**Duke Energy Kentucky
Case No. 2015-00089
Attorney General Second Set Data Requests
Date Received: May 1, 2015**

AG-DR-02-001

Inter-Cell Liner Attachment Details

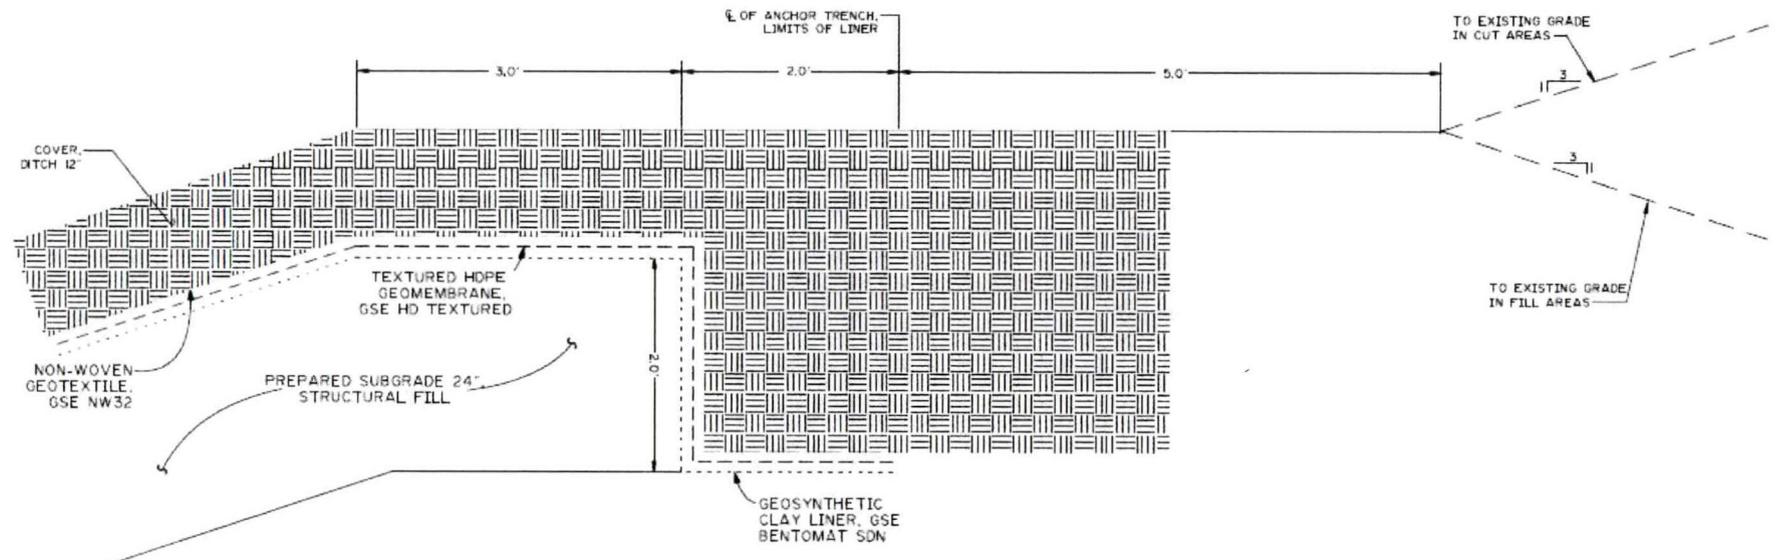
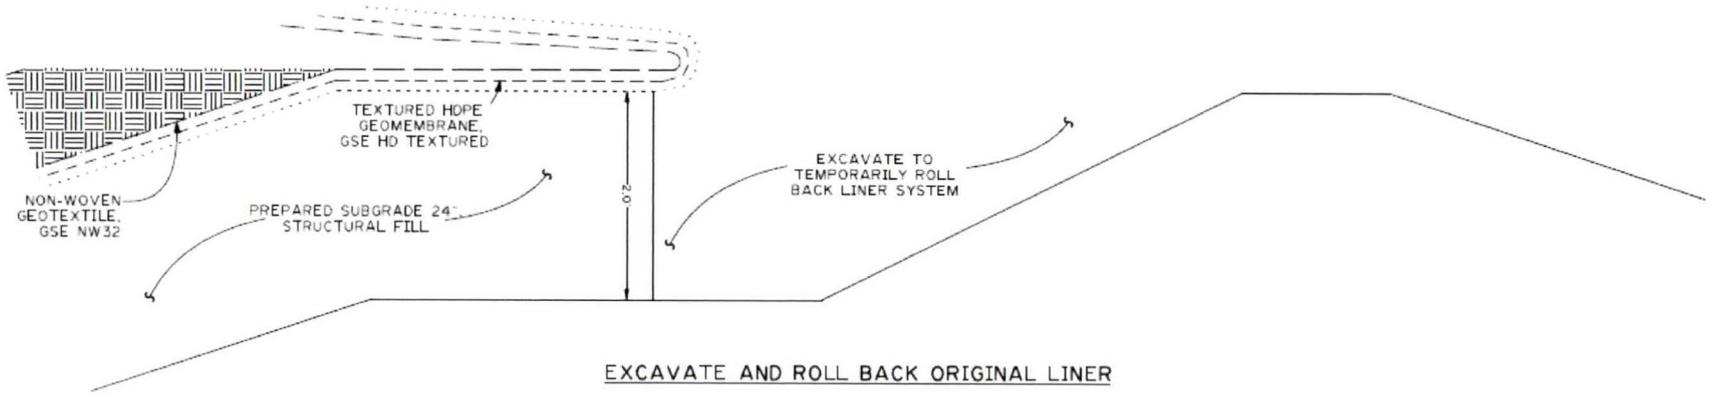
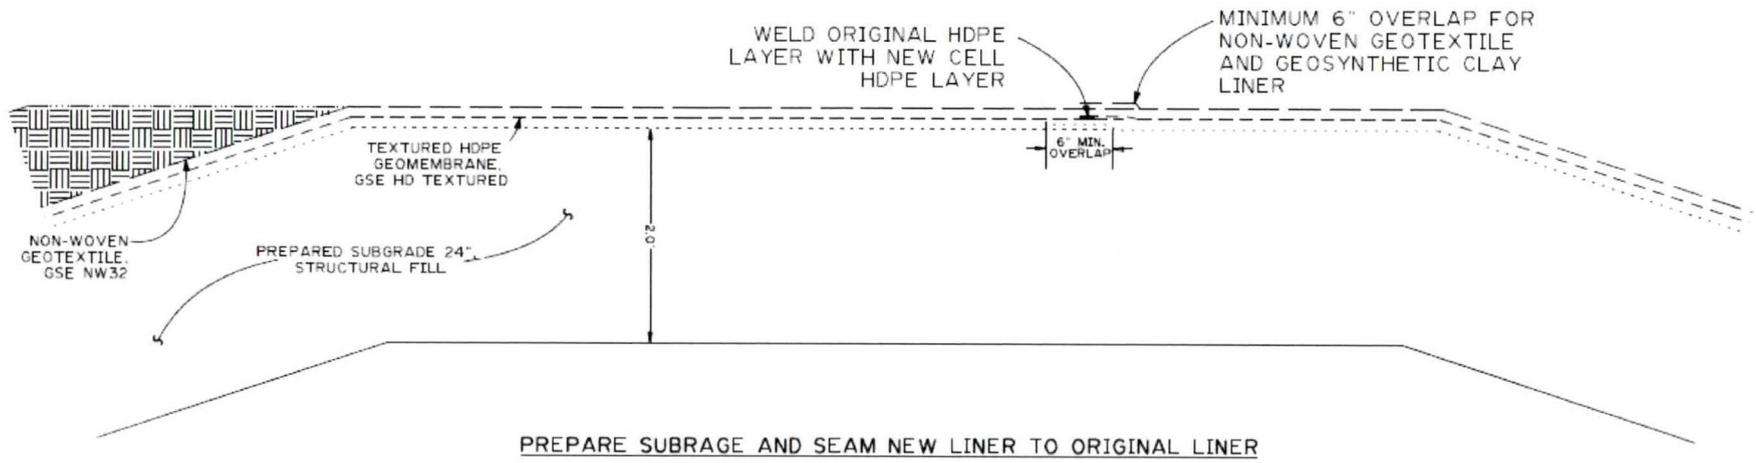
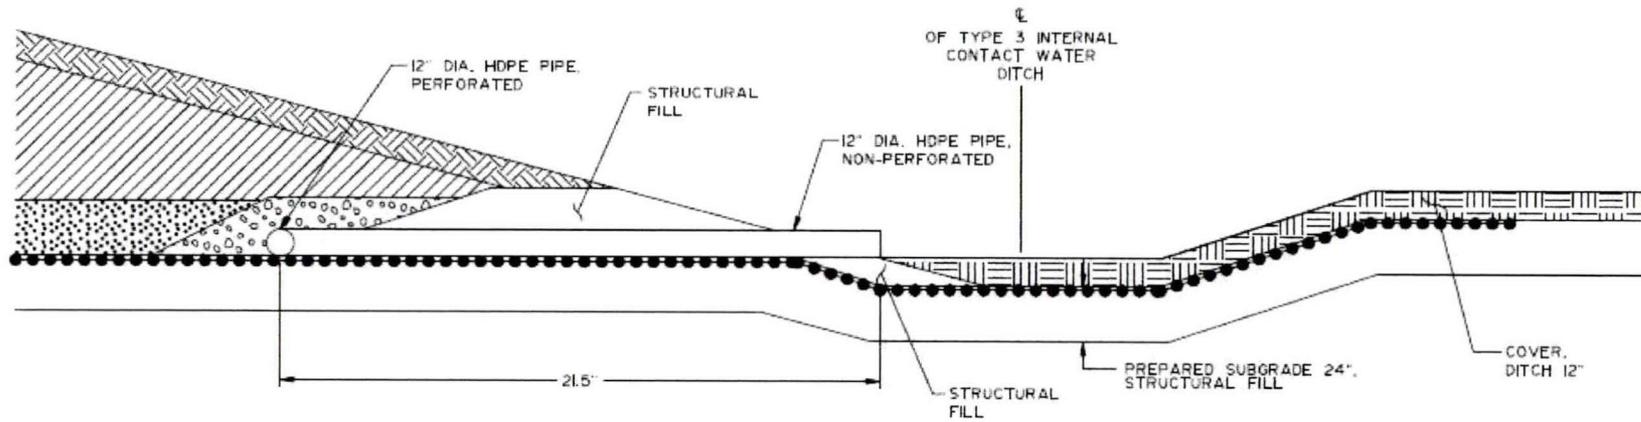
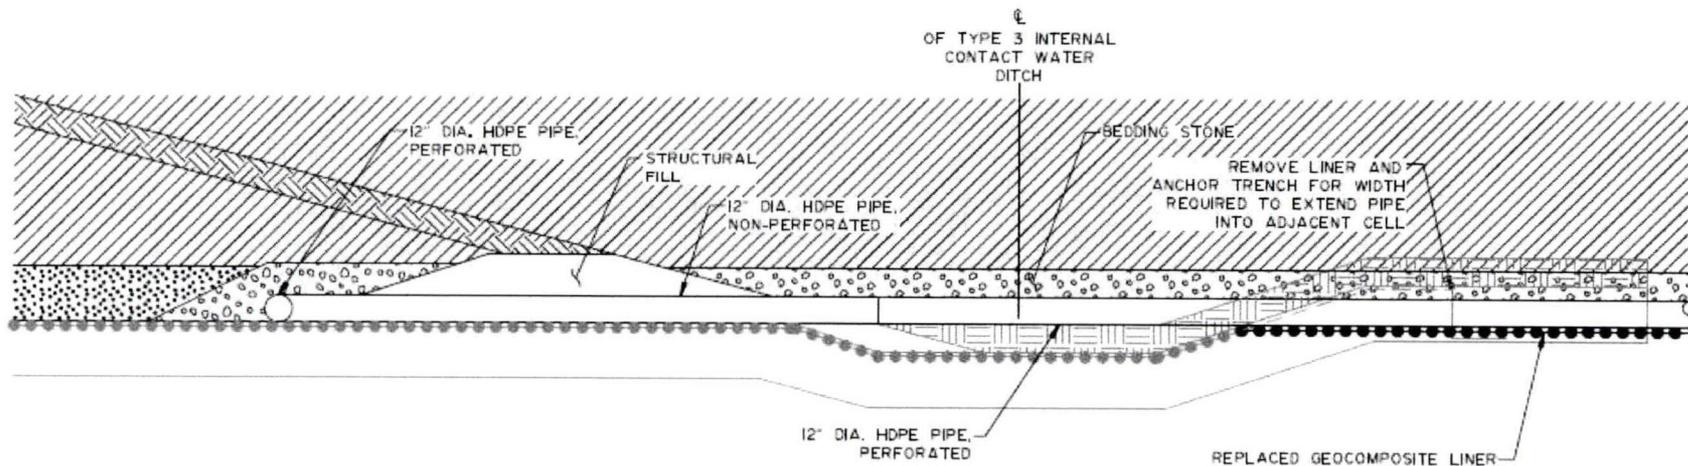
- a. Do the individual cells tie into one another's liner system and leachate prevention system?
- b. If so, how does the first cell, which is not CCR compliant, tie into the additional cells to be built later?

- a. Yes, individual cells tie into one another's liner and leachate collection systems. The liner systems for Cells 1 through 5 of the proposed landfill tie to each other. This detail is shown in AG-DR-02-010 Attachment A. Please note that this drawing is a part of the original permit to install drawing package and does not reflect the 2' clay liner that is required by the CCR rule.

In more detail, Cell 1 leachate flows to Cell 2 which in turn flows to Cell 3. This detail is shown in AG-DR-02-010 Attachment B. Cell 3 leachate flows to the sedimentation pond. Cell 5 flows to Cell 4 which flows to Cell 3, also. Cell 8 leachate flows to Cell 4 to Cell 3 to the pond. Cells 6 and 7 are built on top of Cells 1 through 5 thus the leachate flows from Cells 6 and 7 through the leachate collection system that will already be installed in those cells.

b. To clarify, Cell 1 will be CCR rule compliant. It is a matter of construction timing as to which liner will be required by the CCR rule for Cell 1. If Cell 1 is constructed with a different liner system than the rest of the cells, it will be tied into the additional cells to be built later by assuring that the drainage from the leachate piping in Cell 1 is properly maintained into Cell 2. This is not an unusual situation to occur while building a CCR landfill, and it has been done before at other Duke Energy CCR landfill facilities. For example, leachate piping has been connected from one cell with a three-foot thick liner into another cell with a five foot thick liner. As long as the leachate pipes are arranged to continue positive drainage, the system works effectively.

CELL 1 BASE OF LINER SYSTEM GRADES

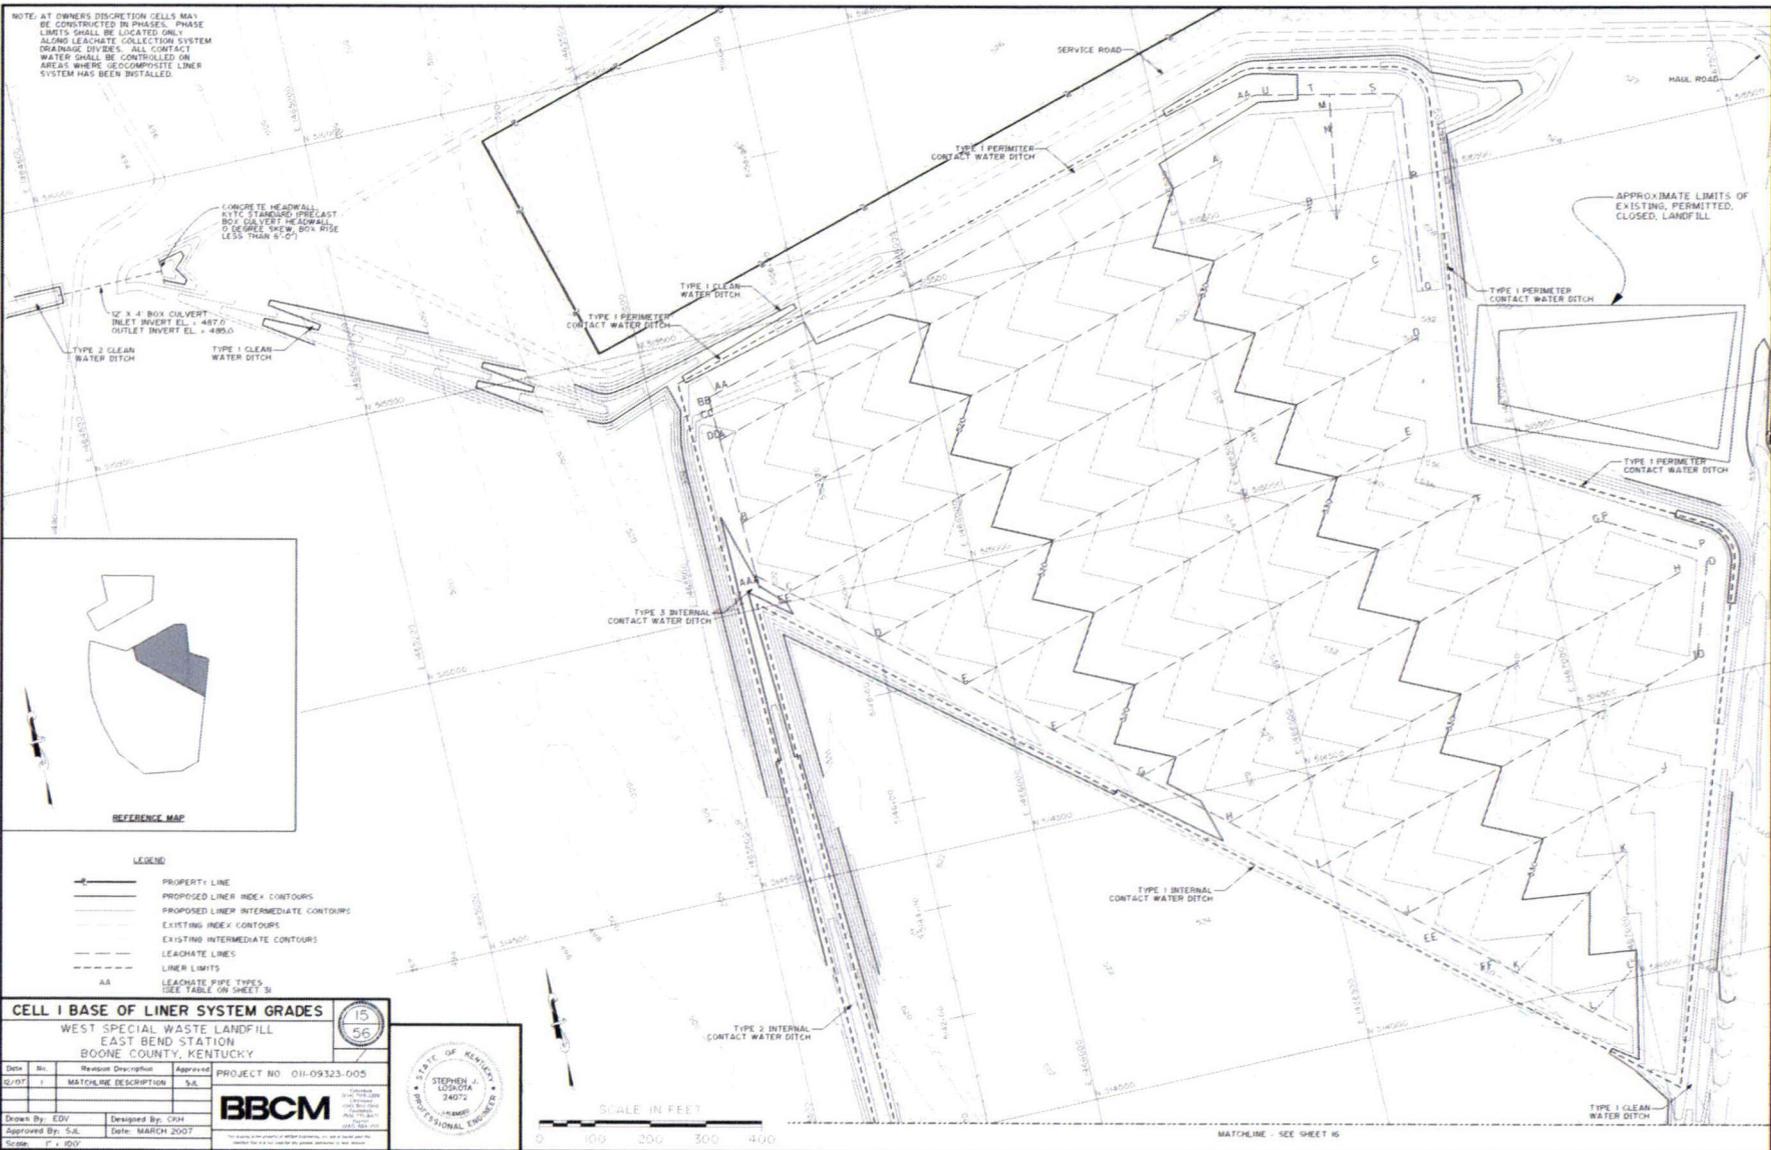
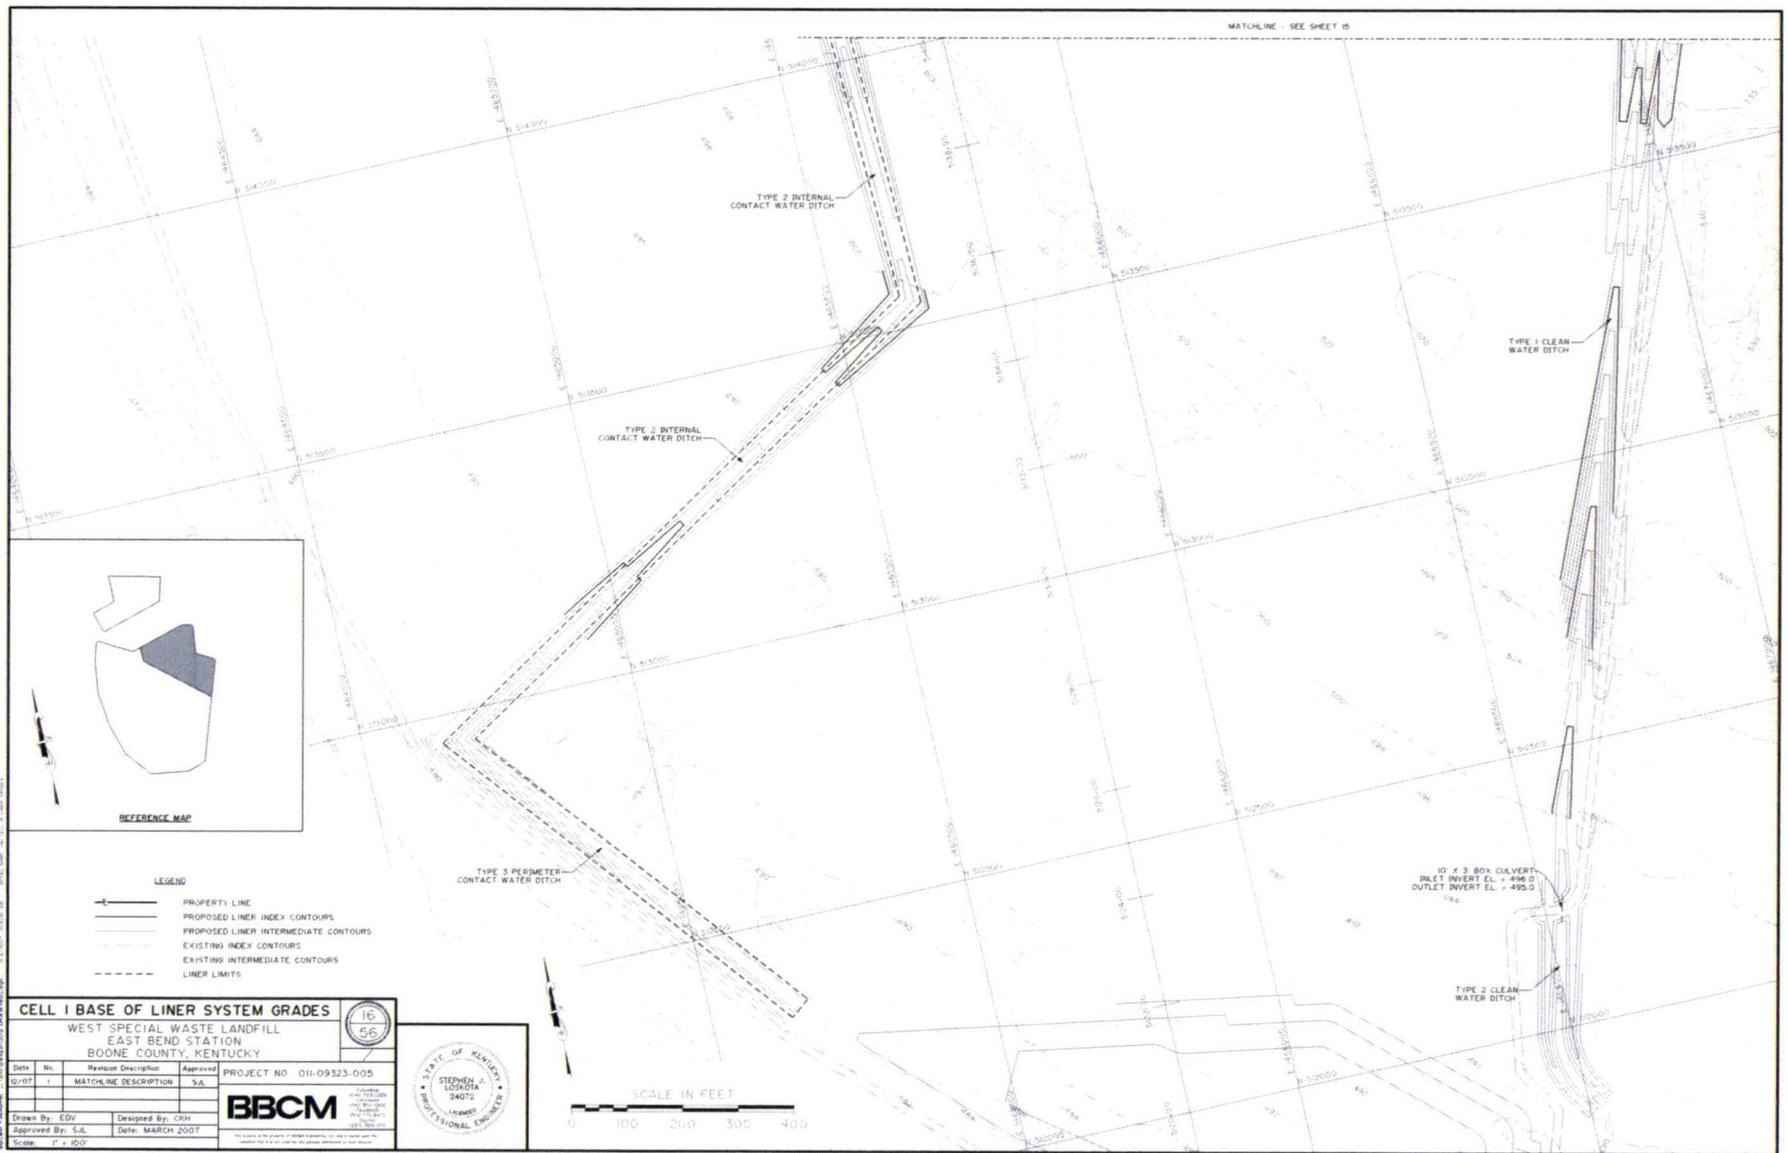
Please provide a diagram of how the cell design and layout will be constructed.

Please see AG-DR-02-011 Attachment. The cells will be constructed in the following order: 1, 2, 3, 4, 5, 6, 7, and 8. The drawings are placed in this order in the Attachment. The drawings labeled "Base of Liner System Grades" show the cells when they have no CCR in them. The drawings labeled "Top of Cover Grades" show the cells when they are full. The Cross Section drawings show elevations of the landfill at the stations that are shown in the plan views.
